# UNITED STATES PATENT AND TRADEMARK OFFICE

APPLICATION NO.	FILING DATE	FIRST NAMED INVENTOR	ATTORNEY DOCKET NO.	CONFIRMATION NO.
10/649,730	08/28/2003	Junji Ando	242169US3	5708

<b>Office Action Summary</b>	<b>Application No.</b> 10/649,730	<b>Applicant(s)</b> ANDO ET AL.	
	<b>Examiner</b> Saúl J. Rodríguez	<b>Art Unit</b> 3681

This is a first office action on the merits of patent application S. N. 10/649,730.

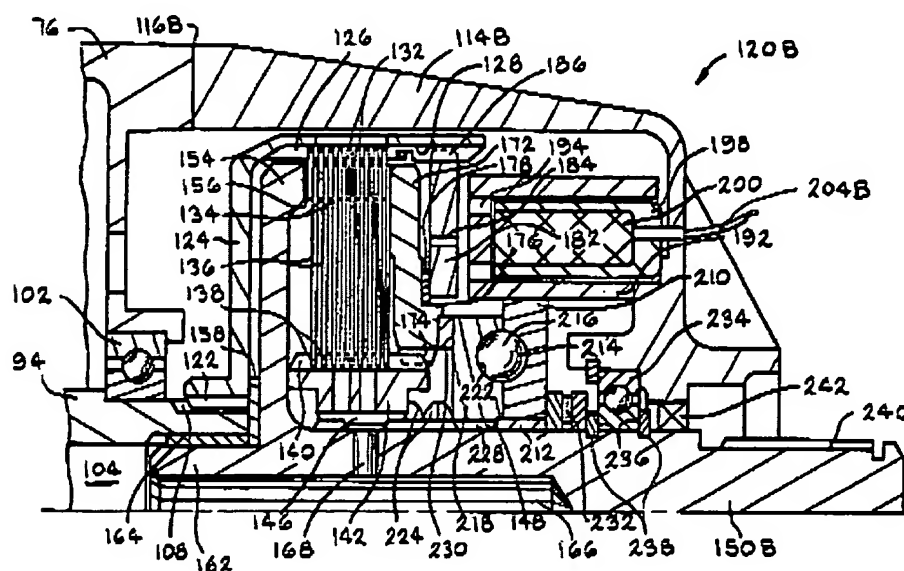
Claims 1-2, and 10 rejected under 35 U.S.C. 102(b) as being anticipated by Isley, Jr. ('770).

Isley discloses a drive power transmission device (Fig. 3) comprising first and second cylindrical rotary members (124, 142), a main clutch mechanism (120B), plural outer plates (132), plural inner plates (138), an electromagnetic pilot clutch (200), a pilot outer plate (182), a pilot inner plate (192), an electromagnet (200), a cam mechanism (216), a weaving electromagnetic path (Col. 6, lines 21-38), and arc slits (184, 194).

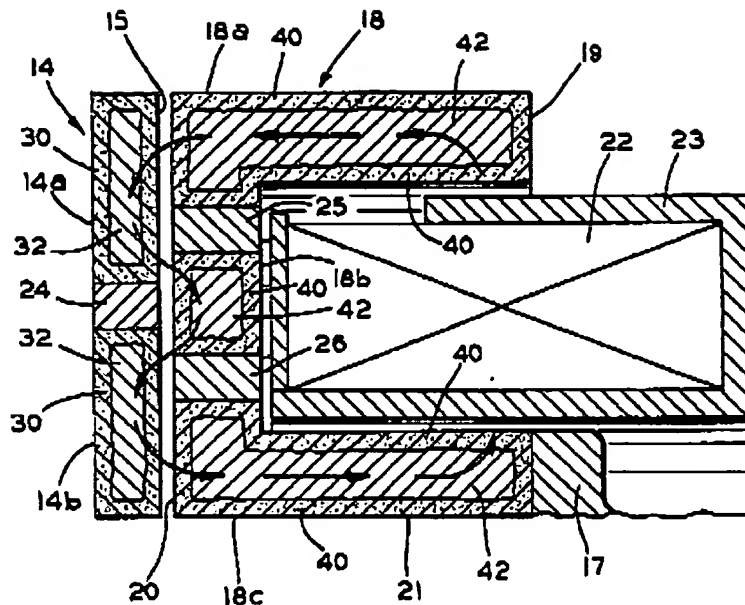
Claims 3-5, 7 are rejected under 35 U.S.C. 103(a) as being unpatentable over Isley, Jr. ('770) in view of Drawl et al. ('421).

Isley does not show sliding surfaces comprising a diamond-like carbon surface.

Drawl, on the other hand, teaches a conventional DLC film for extending the life of a surface exposed to frictional contact.

Then, it would have been obvious to a person of ordinary skill in the art at the time the invention was made to treat the friction surfaces of Isley, Jr. with a DLC surface in view of Drawl to toughen the coupling.
